HISTORIC PRESERVATION BOARD  
APRIL 7, 2008  
MARSAC MUNICIPAL BUILDING  
10:00 AM

## Historic Preservation Board Staff Memo

**DATE:** April 7, 2008  
**AUTHOR:** Kirsten Whetstone  
**TITLE:** 147 Ridge Avenue  
**TYPE OF ITEM:** HPB Guidance Request

# Historic Preservation Board Staff Report

**Example of featureless material.**

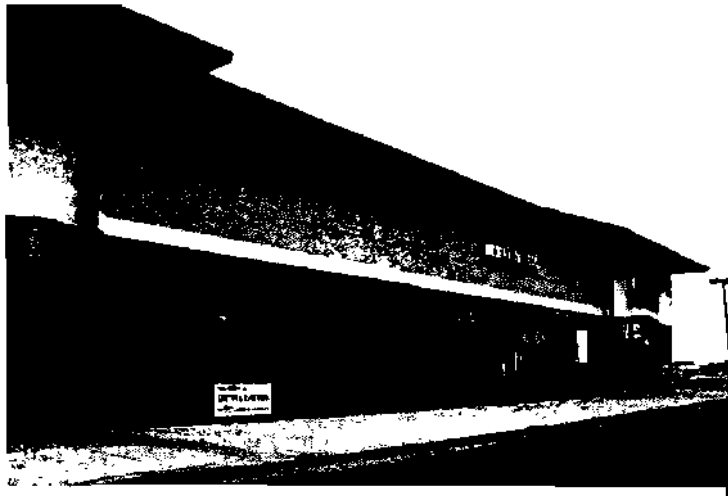
**Comment #11 (Ford): Commercial Infill – What is an example of “featureless material”? I think back to the new museum, of which I am not a fan. That has large expanses of what I would consider featureless materials. In fact, the entire new building is featureless.**

Response: This is an area where consistency in the decision making process is critical. The best way to define this is by being consistent in approving and/or denying materials that are proposed in the design review applications.
